US COMMISSION OF FINE ARTS PRESENTATION | JULY 18, 2019

World War One Memorial

Response to Sculpture and Lighting Comments + Site Security and Final Detailing

Hess Linea Bollard

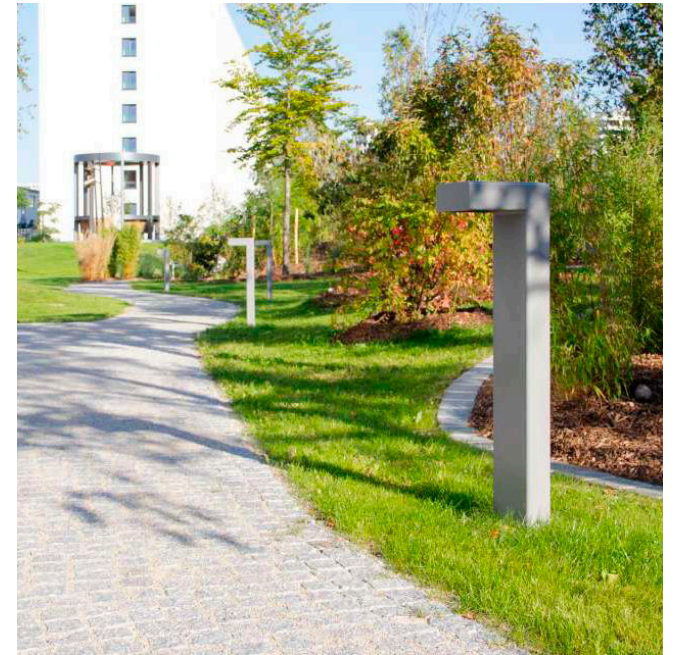
- Questioned the removal of the 12 historic multi-globe fixtures along the upper walkway, emphasizing their important role in the shaping of a coherent spatial experience
- Concluded that using a single fixture type for multiple conditions compromises the geometric structure and spatial clarity of the plan, particularly along the upper walkway
- **Maintain the existing light fixtures but remove the light sources so the fixtures remain as a sculptural element but do not provide illumination**
- **Additional pathway lights and tree uplights required to meet the minimum lighting levels and design goals**

NE CORNER - CONTINUATION OF PA AVE PLANTER BENCHES WITH BACK ADDED

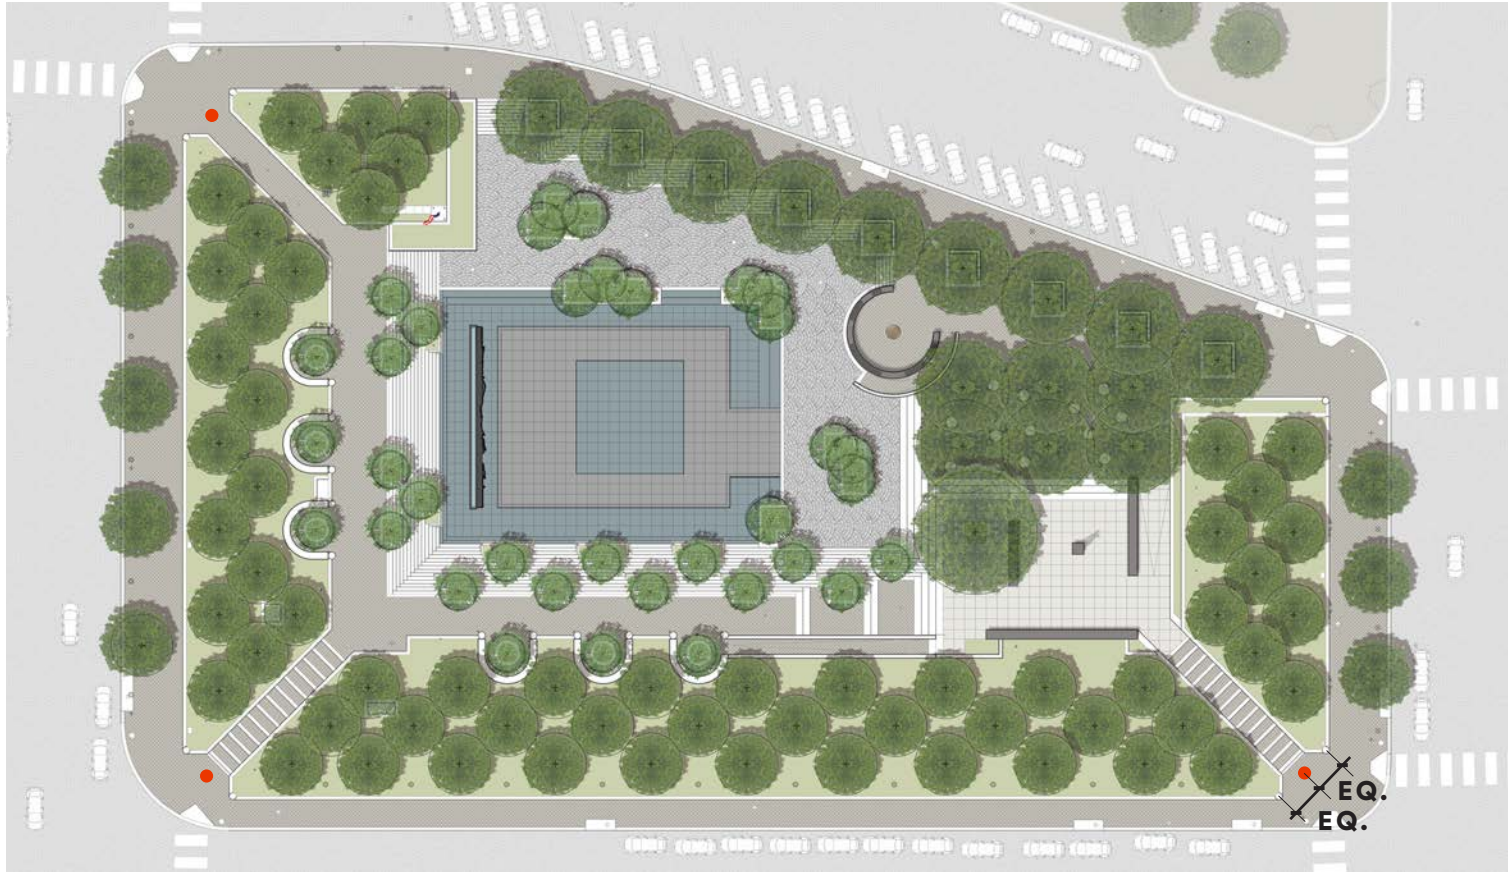
- Continuation of the PA Avenue benches and planters
- Planting and S/W sides also elevated to 18" to increase stopping power of barrier
- A back is added bringing the full height up to 30" to maximize security barrier effectiveness
- Blocks views into the park
